**ADDENDUM NO. 1**  
**to the**  
**PROJECT DOCUMENTS AND SPECIFICATIONS**  
**for**  
**VPS CHILLER REPLACEMENT**  
**DESTIN-FORT WALTON BEACH AIRPORT**  
**(ITB AP 27-18)**

**AVCON Project No. 2017.050.11**

**Addendum Date: July 3, 2018**

**ADDENDUM NO. 1  
VPS CHILLER REPLACEMENT  
DESTIN-FORT WALTON BEACH AIRPORT  
(ITB AP 27-18)**

AVCON PROJECT NO. 2017.050.11  
**SHEET NUMBER**  
**G-004**

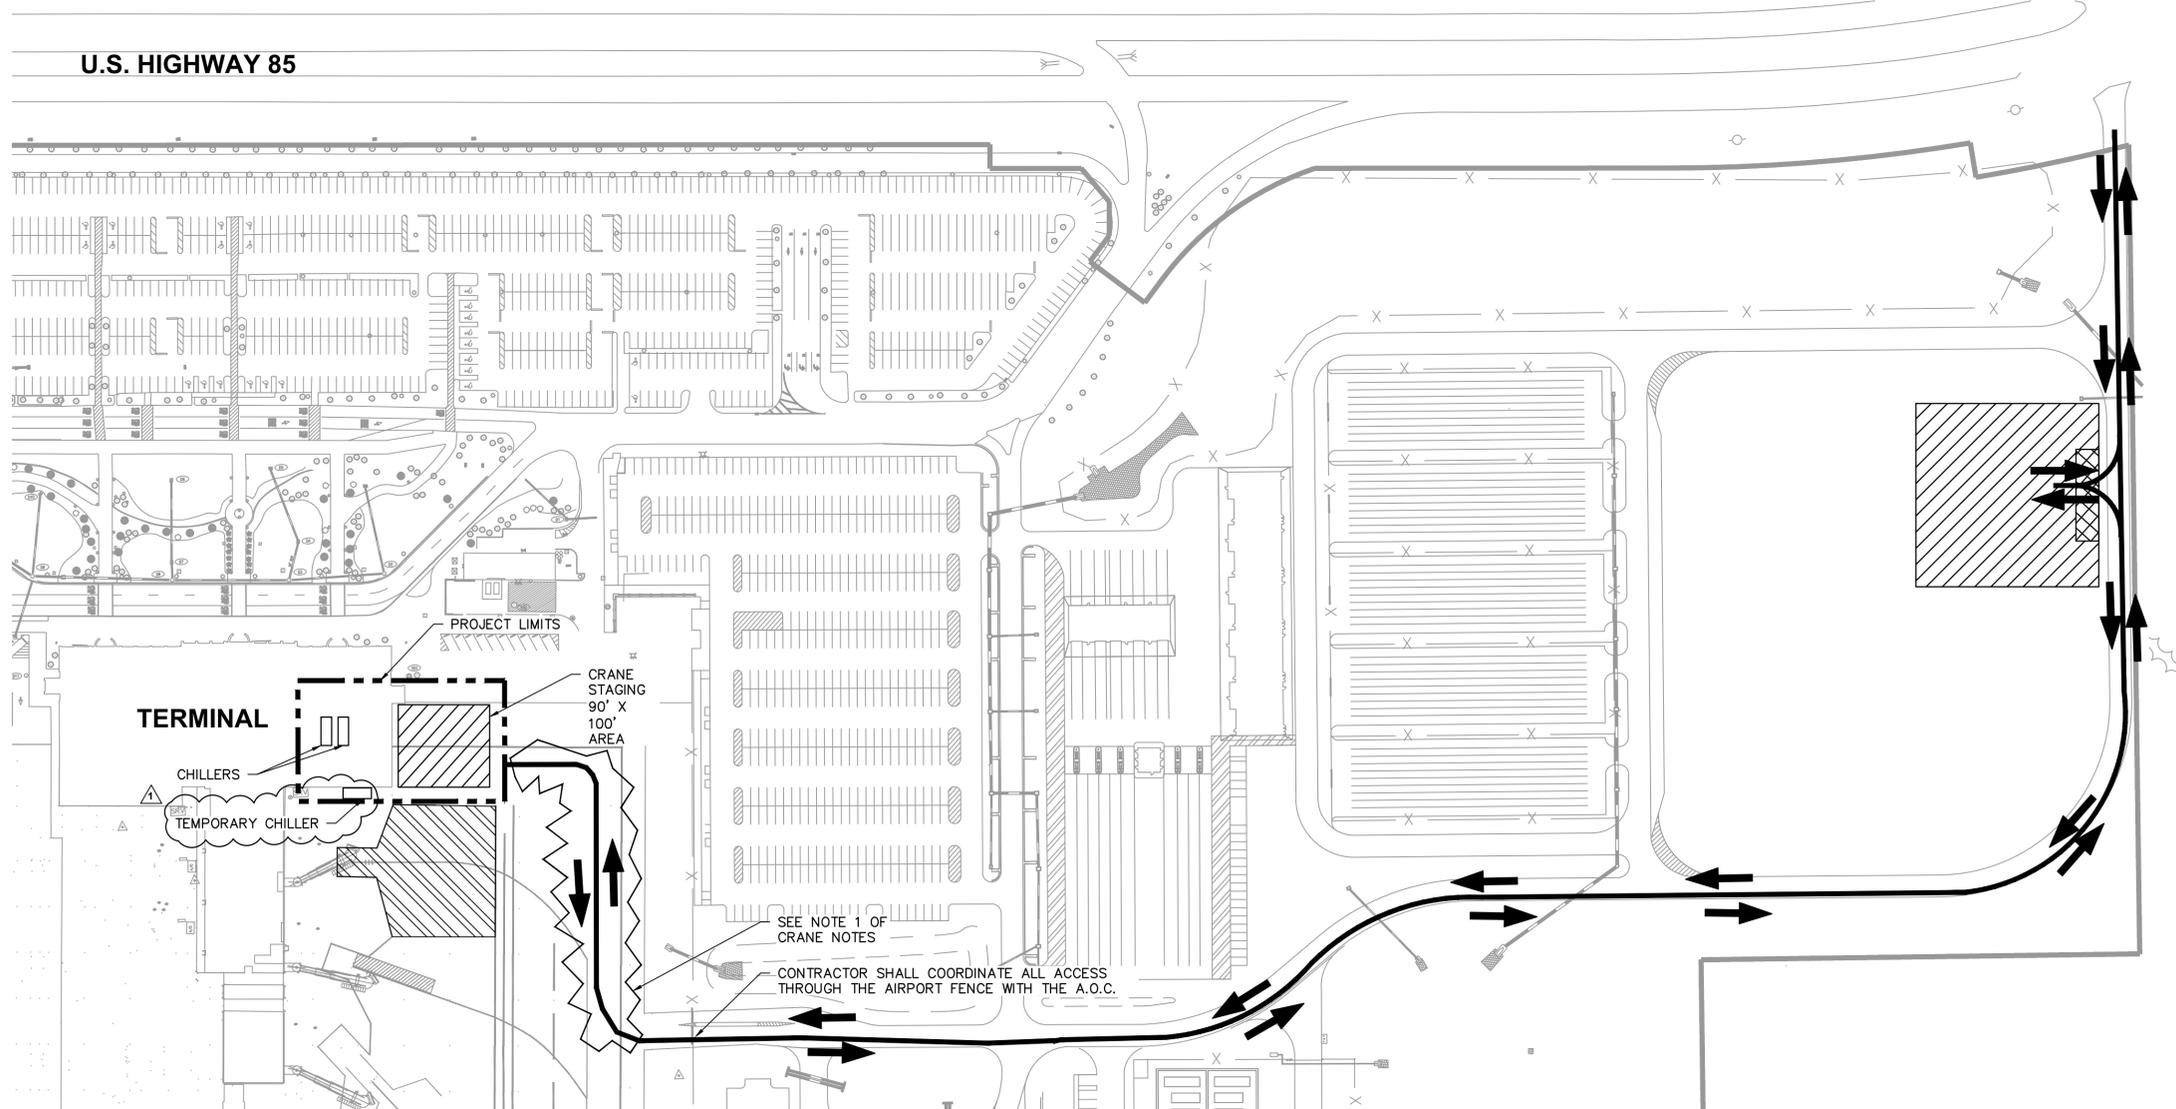
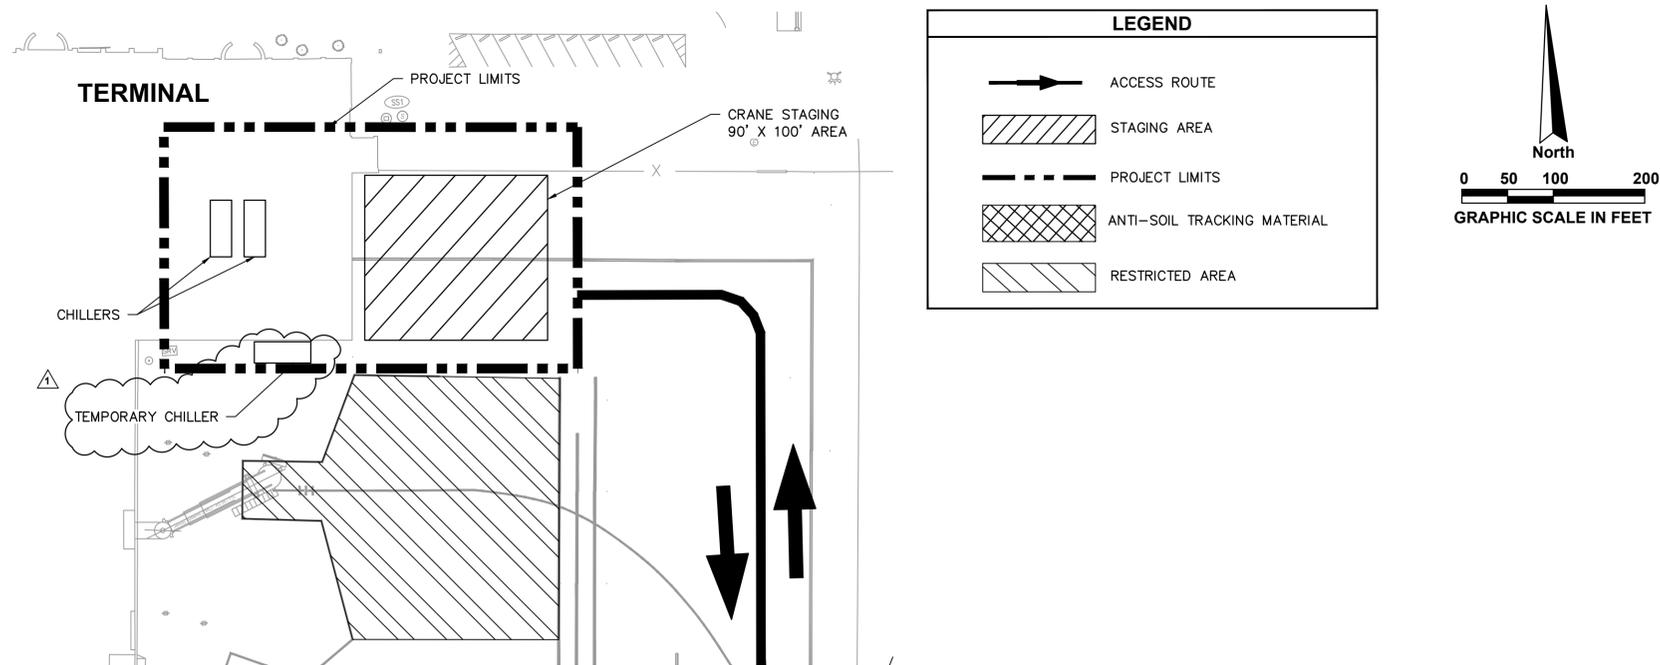
1. Sheet G-004      **REPLACE** Sheet G-004 with Sheet G-004 attached hereto at **Attachment A**.
2. Sheet M-114      **REVISE** Mechanical Key Note 2 as follows:

6. TEMPORARY CHILLER SHALL BE LOCATED TO AVOID IMPACTS TO BAGGAGE CART ACCESS.

*RESPONSE: Please refer to sheet M-103 Mechanical Phasing Plans and revised Sheet G-004 for location of temporary chiller.*

**SHEET NUMBER**  
**M-114**

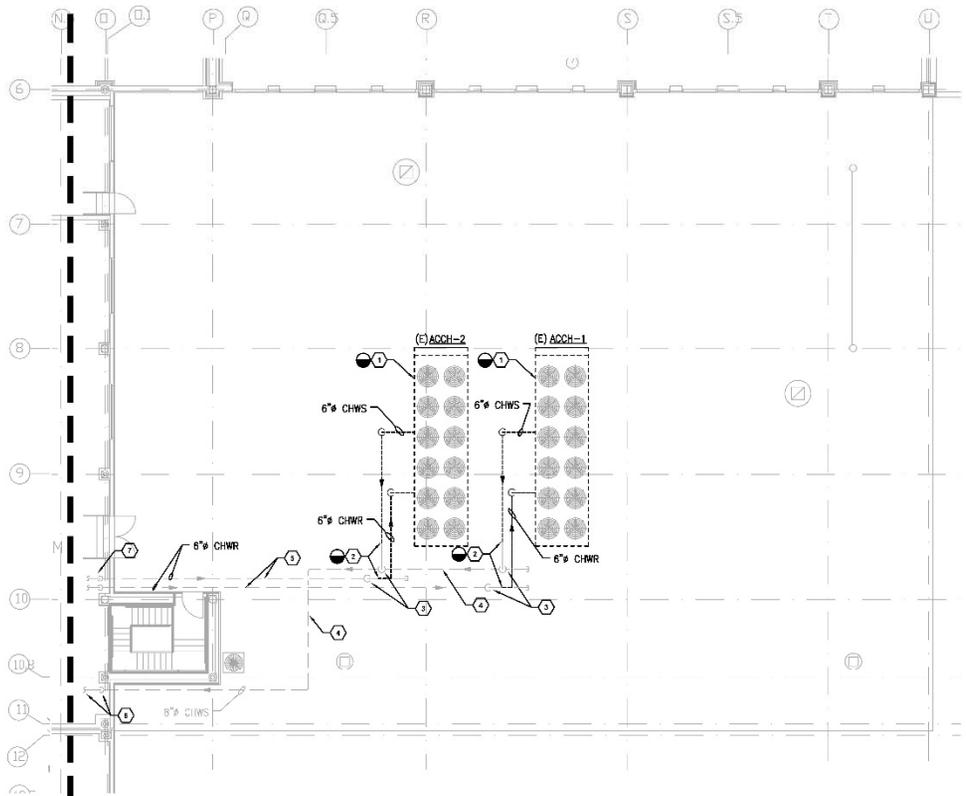
“New variable frequency drives for CWP-1, 2 & 3. Refer to Specification Section 23 05 17 and chilled water system control sequence of operation and schematic on Sheets M-701 & M-702. *New rack shall be properly bolted to the floor slab.*”

2. Will we need to pour a house keeping pad for the new VFD's or will the rack bolt directly to the floor or adjacent wall?

*RESPONSE: Concrete base for VFD rack is not required. Contractor shall properly anchor the new rack to the floor slab. This will be clarified on Sheet M-114 in Addendum No. 1.*
